RE: **1625 Valdez Dr. NE**
Grading and Drainage Plan
Engineers Stamp Date 9/7/2021
(J23D031)

Based upon the information provided in your submittal received 9/7/2021, this plan is approved for Grading Permit.

DRAINAGE AND TRANSPORTATION INFORMATION SHEET (REV 6/2018)

ENGINEER'S SEAL  DAVID SOULE P.E. #14522	1625 VALDEZ	DRAWN BY: WCVJ
	GRADING AND DRAINAGE PLAN	DATE: 8-06-21
 Rio Grande Engineering 1606 CENTRAL AVENUE SE SUITE 201 ALBUQUERQUE, NM 87106 (505) 872-0999	SHEET #	210210082-LAYOUT-B-27-21
		JOB # 21021082

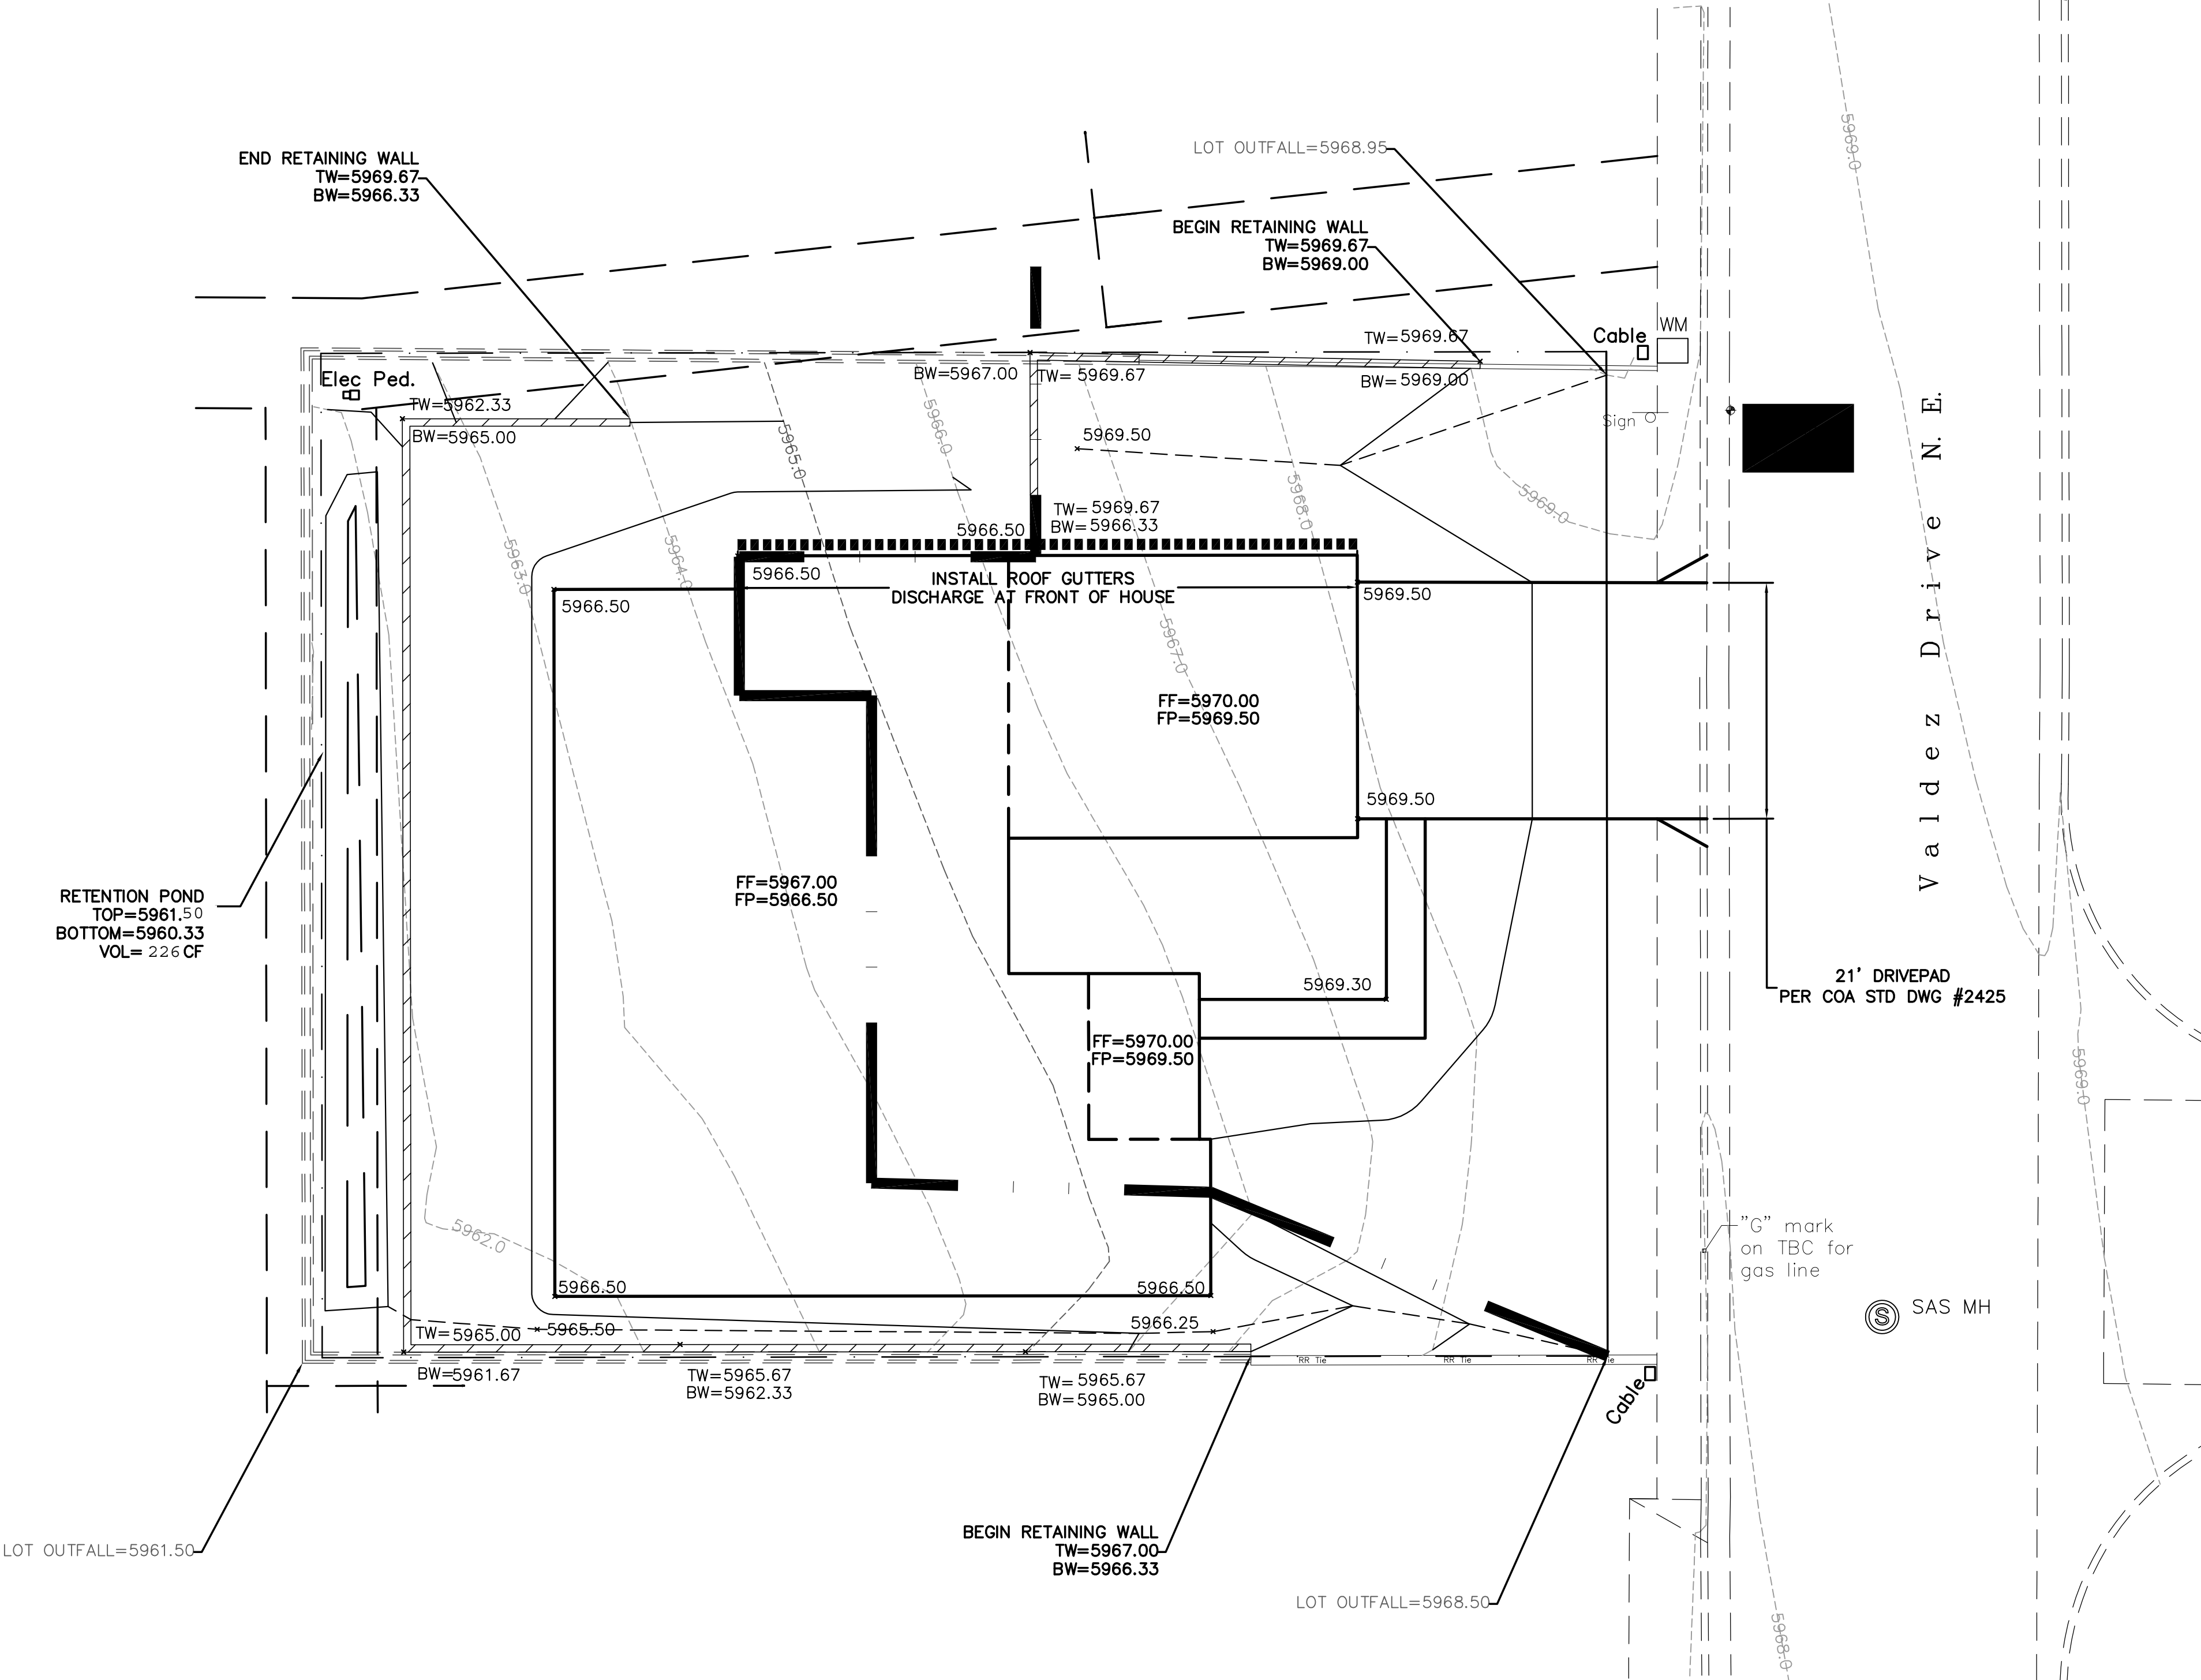
Prior to Building Permit approval, a **Pad Certification** will be required. Inform the contractor/owner not to pile dirt in the street as a ramp to climb the curb. If dirt is found in the street the pad cert. will be denied.

Prior to Certificate of Occupancy release, Engineer Certification per the DPM checklist of this plan will be required.
